# REGIONAL REVIEW FINDING

ARC REVIEW CODE: R14052101

**Name of Proposal:** Braves Stadium and Mixed Use Development

**SUBJECT:** **Transportation Division Review of DRI # 2381**  
Project: Atlanta Braves Stadium and Mixed-Use Development  
County: Cobb  
Location: Block bordered by Circle 75 Pkwy to the South and East, Windy Ridge Pkwy to the North, and Cobb Pkwy/US 41 to the West

**Figure 1: Pedestrian Connection between “South Parking” and Braves Development Site**

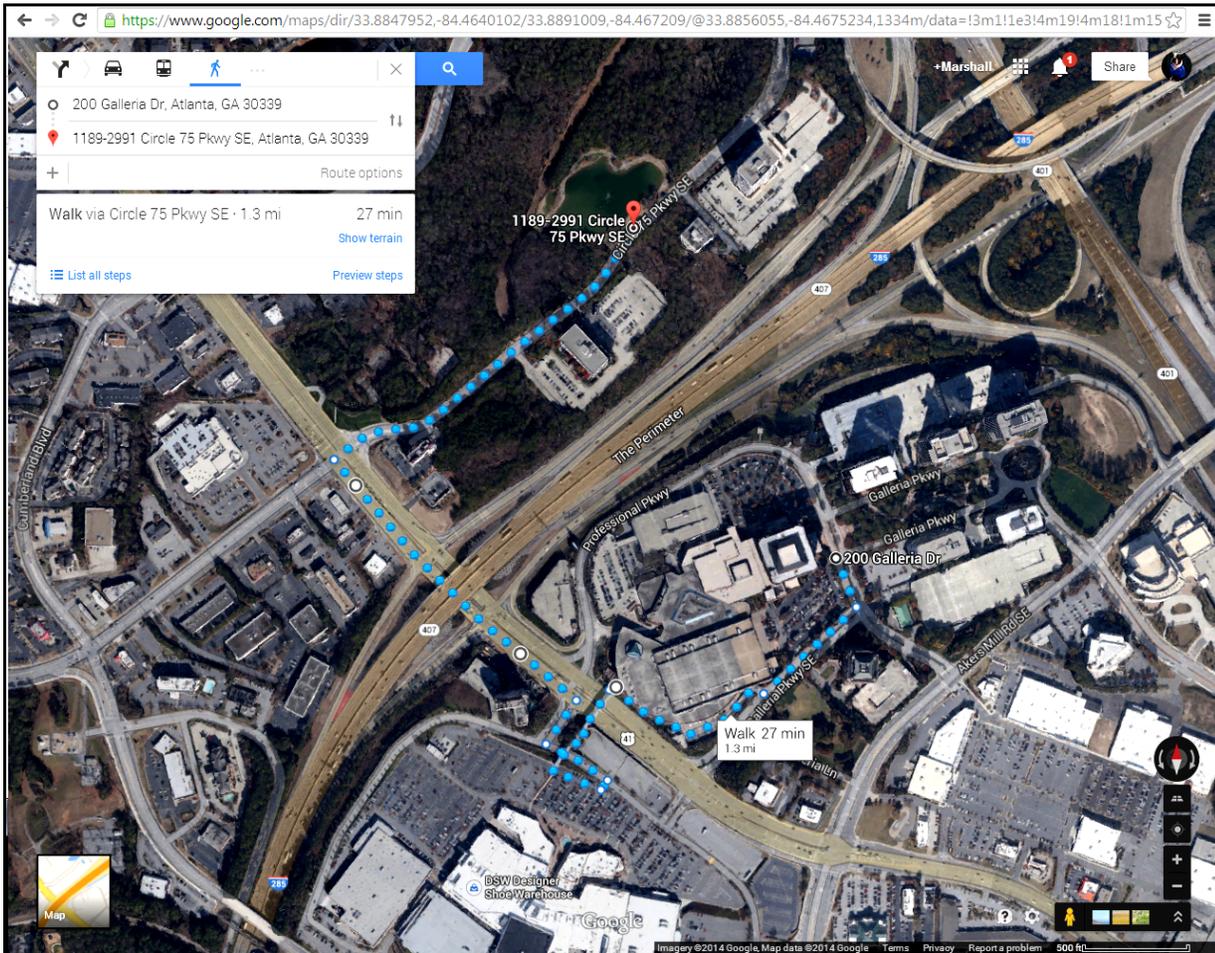
Approximately 35% of vehicles will park in the “South Parking” area (see Figure 7 in the Transportation Analysis submitted by Kimley-Horn & Associates). The pedestrian connection from that area’s midpoint to the Braves stadium is a 1.3 mile walk (27 minutes). There is no sidewalk on the northbound side of Cobb Parkway between the Cobb Galleria complex and the I-285 West exit ramp at Cobb Pkwy, thus requiring pedestrians to cross Cobb Pkwy via the Cobb Galleria/Cumberland Mall pedestrian bridge and then cross again at Circle 75 Pkwy which currently has 11 lanes of travel (the submitted site plan recommends additional lanes). Access from the south of the subject site was not included in the *Bicycle and Pedestrian Facilities* (Section 1.4) of the Transportation Analysis.

- One example is there are no sidewalks on NB side of Cobb Pkwy at I-285. The lack of sidewalks forces those who park in "South Parking" to cross Cobb Pkwy at Cumberland Mall via pedestrian bridge, then cross 11 lanes at Circle 75 Pkwy (the submitted site plan shows 15 lanes). The sidewalk on the SB side of Cobb Parkway may need to be widened to accommodate the large number of pedestrians that will utilize this facility in accessing the site. Cobb Pkwy in this area has an annual average daily traffic of 42,070 (2012 GDOT STARS data).

- Improvements to accommodate a large number of pedestrians may include widening sidewalks along Cobb Parkway, constructing additional sidewalks along the NB side of Cobb Pkwy, creating a pedestrian island on Cobb Parkway @ Circle 75/Spring Road, improved pedestrian signalization such as rapid flashing beacons and hawk signals where appropriate, increased presence of police officers at key intersections, etc.

**Figure 2: Pedestrian Connection from Cumberland Transfer Center to Braves Development Site**

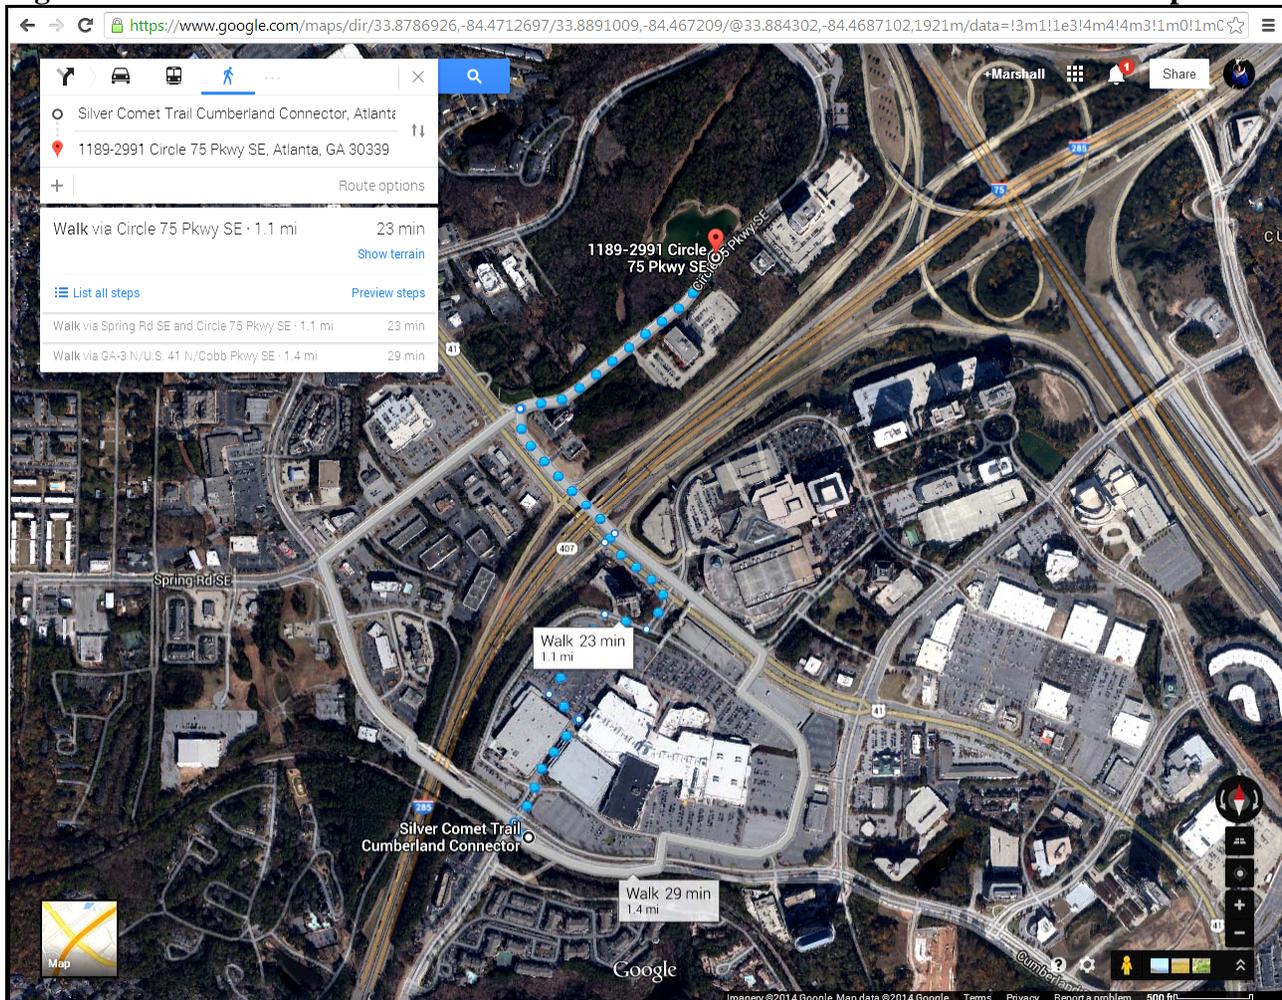
The site is directly served by Cobb Community Transit. The Cumberland Transfer Center is located on the south side of Cumberland Mall and is served by MARTA Bus Route 12 (between Midtown, Atlanta and the Cumberland Transfer Center), and Cobb Community Transit Bus Routes 10, 10A, 10B, 20, and 50. The Cumberland Transfer Center is an approximate 1.1 mile, 23-29 minute walk to the subject site (Figure 2).
